Docket Item # 4
BAR CASE #2011-0325

BAR Meeting
May 16, 2012

ISSUE: Signage and awnings

LOCATION: 100 South Fairfax Street

Figure 1. Historic photograph showing blade sign at the northwest corner, date unknown, likely 1950s.

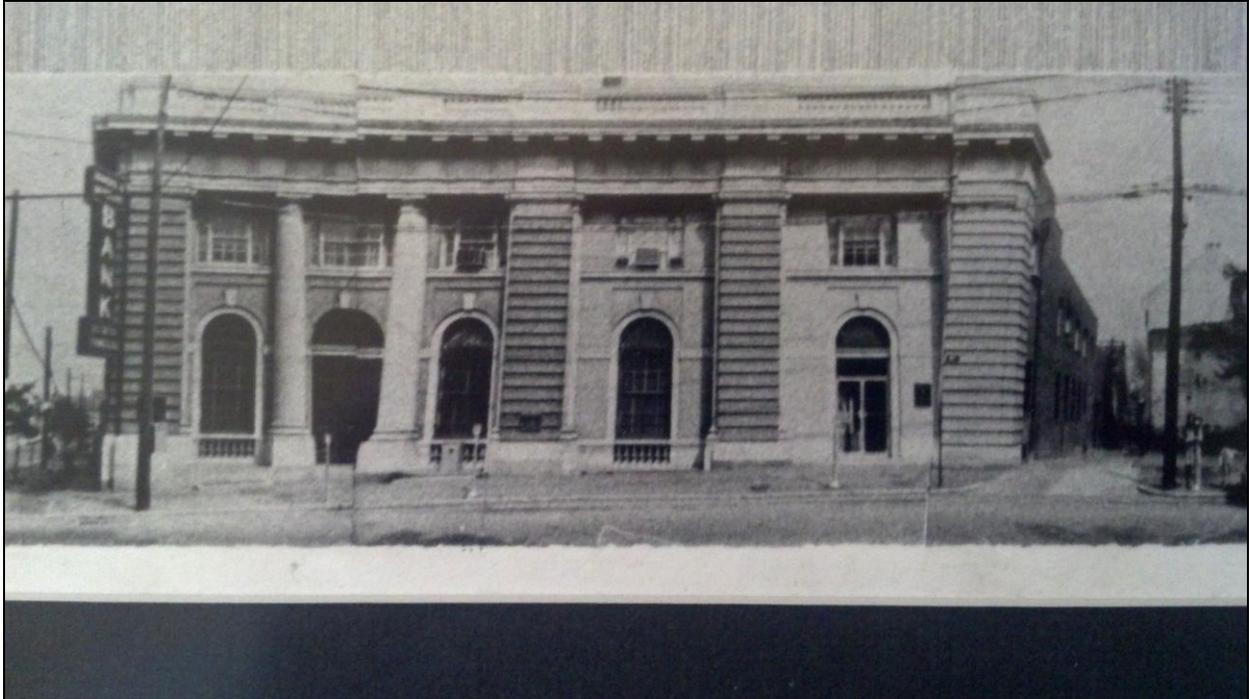
Although no date is known, a historic photograph provided by Burke & Herbert shows a large blade sign at the corner of King and South Fairfax streets. Presumably, it was illuminated and it was likely installed well before 1952. A similar illuminated sign exists today at the Monroe Avenue branch of Burke & Herbert and was recently refaced. While this is not what the applicant proposes, it does indicate a history of some type of illumination. However, the Board’s recent practice has been a more reserved approach regarding illumination on historic or early buildings consistent with the *Design Guidelines*, approved in 1993, which advise a more reserved and cautious approach to illumination. In addition, the *Guidelines* note that “signs should not...obscure the architecture and decorative features of historic buildings.”

The existing internally illuminated box signs are not consistent with the *Guidelines* and would likely not have been approved today due to the type of illumination and the obscuring of the majority of the entablature. The applicant's proposal will actually uncover and reveal the triglyphs and metopes in the frieze, defining features on one of the finest remaining examples of the Beaux Arts style in Alexandria. Further, as the applicant has indicated in the submitted Light Output Measurement chart, the levels of illumination will be less than half of the current light output. The applicant has also provided a comparison that shows the illumination levels of the existing and proposed signage.

FRONT ELEVATION

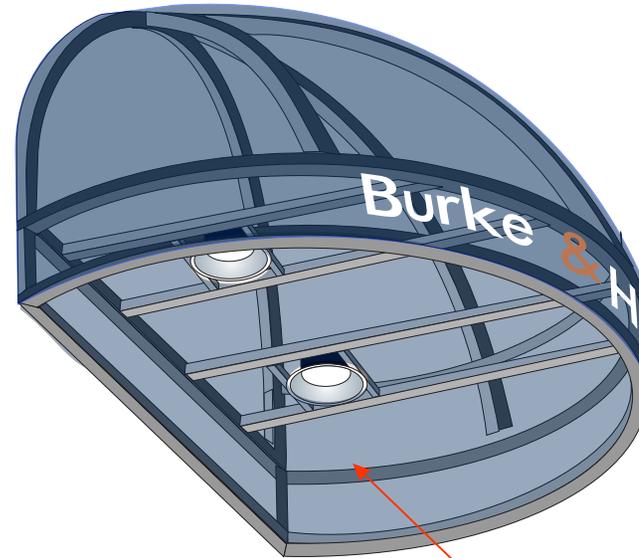
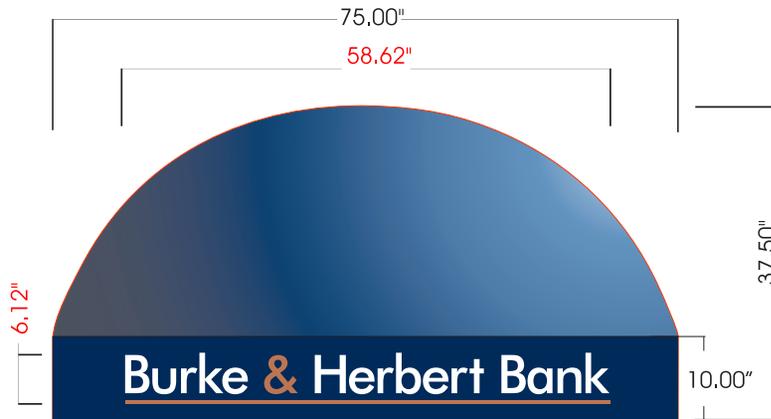
lit awnings are not appropriate in the historic districts and are strongly discouraged.” In this particular case, bullnose awnings are an appropriate shape on the arched fenestration. Staff finds that the three awnings on the South Fairfax façade are generally appropriate and draw a modest amount attention to the entry doors. While internally illuminated awnings are not appropriate, Staff supports the down lights as they are not intended to back-light the awning fabric but rather will provide a soft wash over the architectural features of the building and the entry sidewalk below.
